ADDENDUM NO.2

ENERGY & EFFICIENCY HVAC UPGRADES FOR THE
MILO PECK CHILD CARE SCHOOL
WINDSOR, CT

This addendum issued on December 16, 2021 shall form part of the Contract Documents dated November 10, 2021 and modifies the Contract Drawings and Specifications. The bidder shall acknowledge receipt of this addendum in the space provided on the bid form. Failure to do so may subject the bidder to disqualification. This addendum consists of Seven (7) pages.

TYPICAL STEEL BOLLARD DETAIL
SCALE: N.T.S.

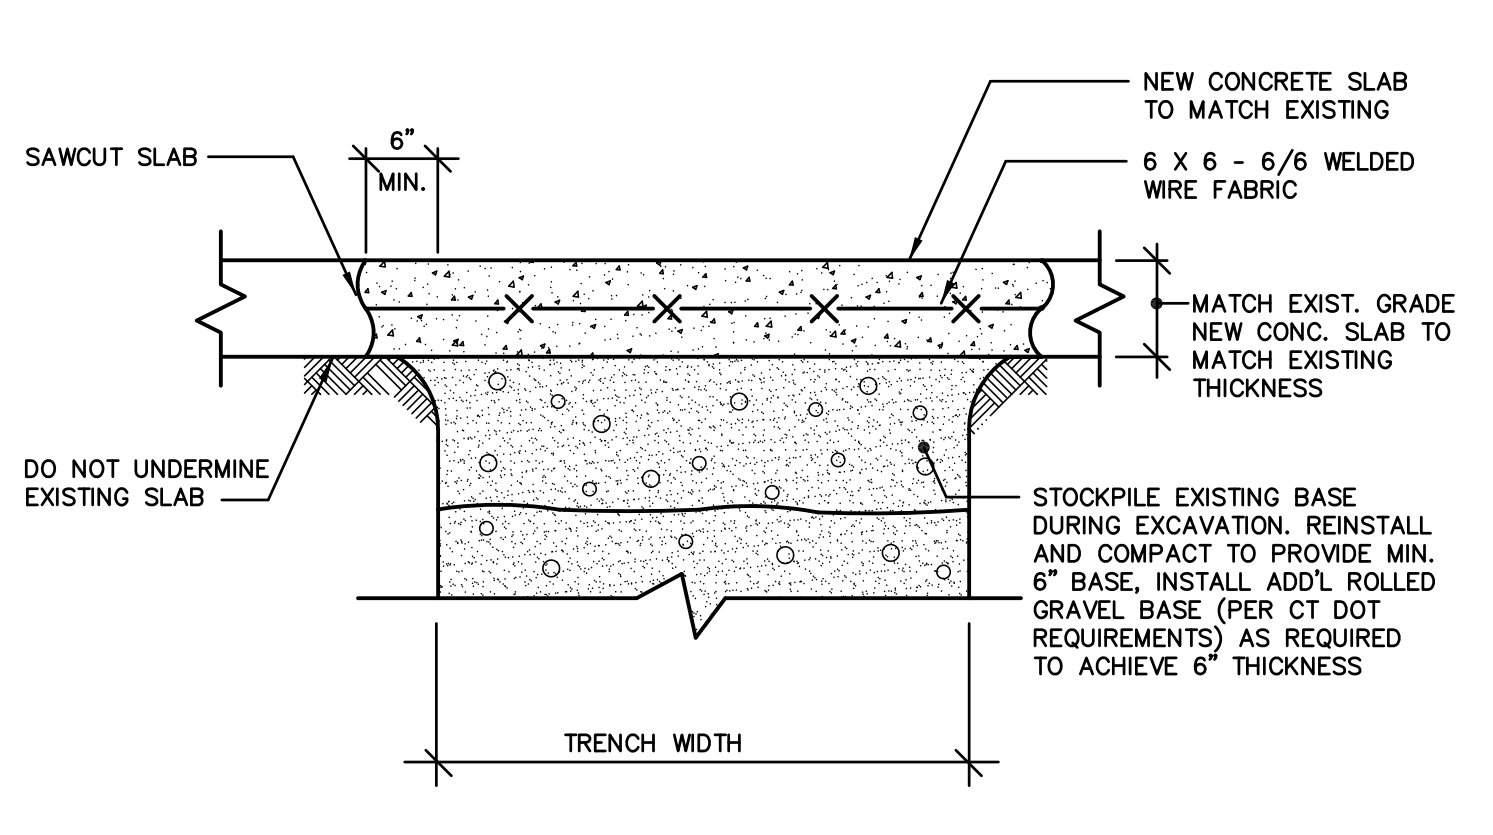
- A. Eversource confirmed proposed transformer pad installation location is acceptable as shown.
2. Are bollards required around the new transformer? If so they will extend into the sidewalk.

- A. 6-inch safety bollards shall be installed for protection of transformer. Provide bollards at the front of parking spaces adjacent to transformer, maximum 5-feet on center. Provide additional bollards located minimum 3-feet from concrete pad edges at the grass side of existing sidewalk, on both sides of the transformer, maximum 5-feet on center. Provide bollards per applicable code and local AHJ.

DRAWING NO.
S-1

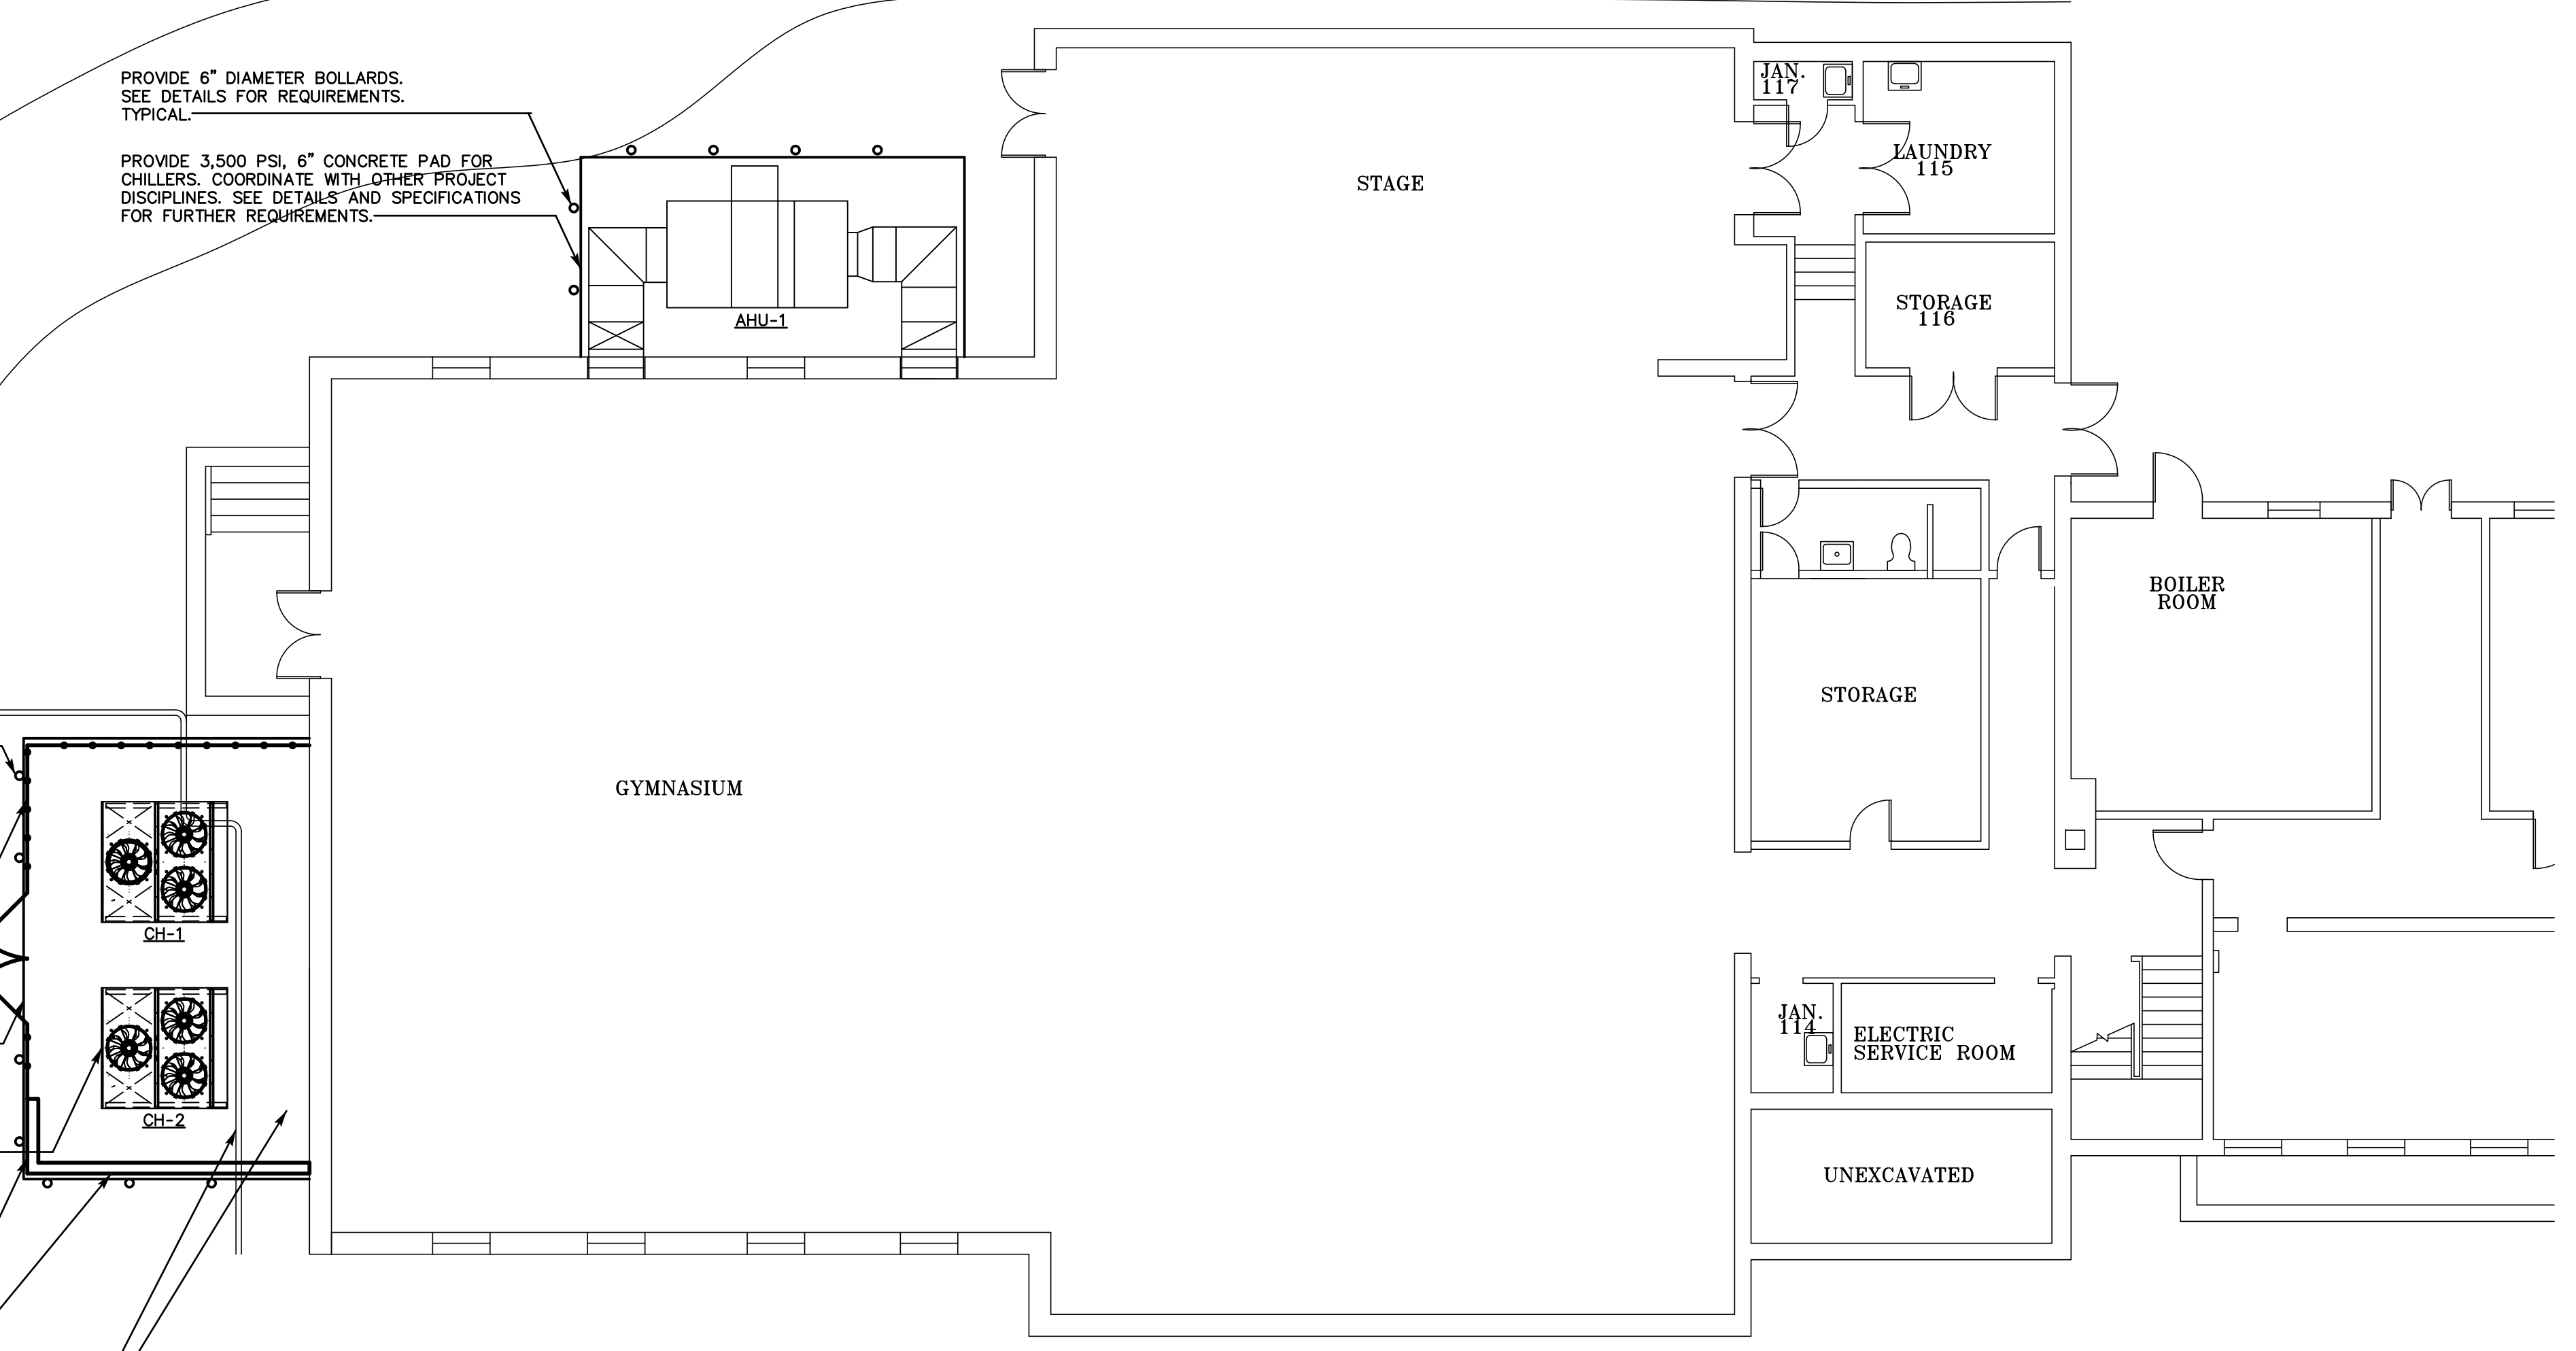
1. S-1: Remove drawing from Bid Set and replace with S-1 attached.
2. S-1: Add the following to the sound barrier wall: See V-STACK-1 Drawing attached (use SECTION A-A-OPTION #1)
3. M-1: Remove four (4) ceiling mounted oscillating fans in the Gym and replace with four (4) ceiling mounted 60" industrial fan equal to Canarm model CP60W11N. Reconnect to existing electrical and fan control as required.
